Final Safety Evaluation Report

HI-STORE Consolidated Interim Storage Facility

Specific Materials License No. SNM-2516

**Office of Nuclear Material Safety and Safeguards
United States Nuclear Regulatory Commission**

Figure 2-1 SAR figure 2.1.2 with localized surface depressions circled in red

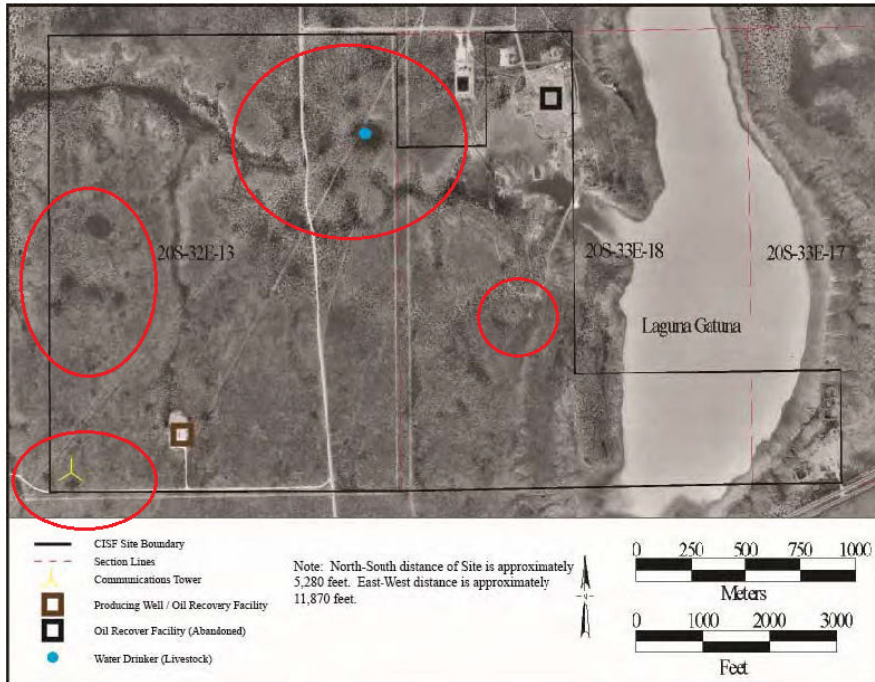
The NRC staff reviewed the applicant's response and, during the June 2019 site visit, observed the fractures and slickensides in the recovered core. Based on this information, the staff determined that the fractures are not due to recent changes in the regional stress regime and the slickensides are pedogenic in origin. Accordingly, the staff concludes that the fractures and slickensides are not tectonic in origin and will not affect the facility or result in surface deformation at the site.

SAR figure 2.6.2 shows the site is underlain by over 300 m (1,000 feet) of the Capitan Reef, a carbonate formation in the site region that is well known for large-scale karst features that have developed at the surface and at depth. Most notable of these features are the Carlsbad Caverns, approximately 105 km (65 mi) southwest of the site. The staff also notes the presence of additional carbonate and evaporite rocks both above and below the Capitan Reef and the association of subsurface halite dissolution above the Capitan Reef with several sinkhole features in southeastern New Mexico. Additionally, as shown in the red circles on SER figures 2-1 and 2-2, SAR figures 2.1.2 and 2.1.5 show numerous circular features that appear similar to swales or sinkholes throughout the site and surrounding areas.

Figure 2-3 Comparison of the NRC staff’s confirmatory PSHA with the DE and DECE for the Holtec site, including the 2014 USGS NSHMP results for selected frequencies

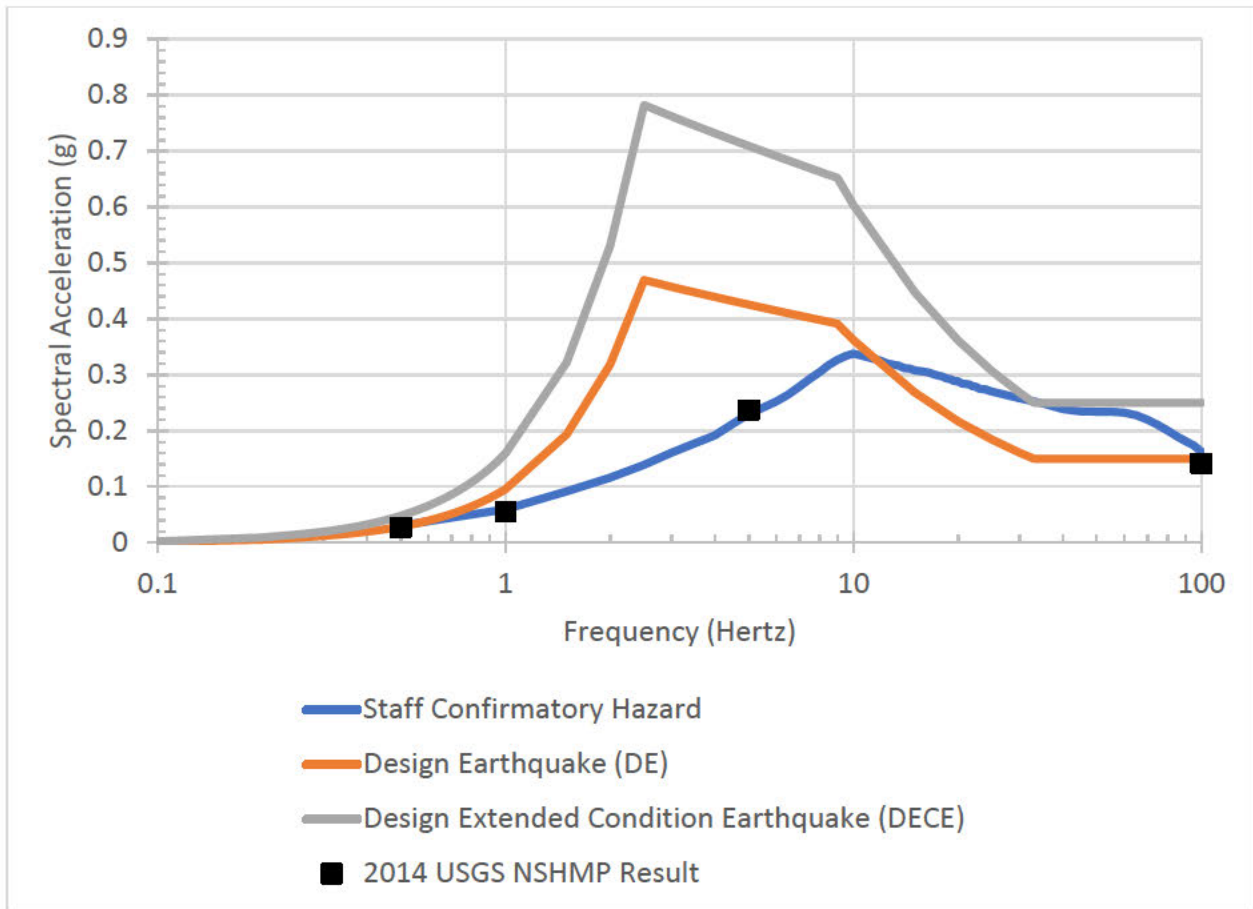
The staff compares its site-specific 1×10^{-4} /year uniform hazard response spectrum to the applicant's DE and DECE in SER figure 2.6.2-1. As shown in SER figure 2.6.2-1, the NRC staff's 1×10^{-4} /year uniform hazard response spectrum exceeds the applicant's DE at frequencies greater than approximately 15 hertz. However, the DECE envelopes the staff's results at all frequencies. The DE and DECE also envelope the 1×10^{-4} /year hazard estimates from the "Documentation for the 2014 Update of the United States National Seismic Hazard Maps," issued by the USGS in 2014. Based on these results, the staff concludes that the DECE adequately accounts for uncertainty in the site-specific seismic hazard and that the applicant adequately addressed site specific ground motion parameters.
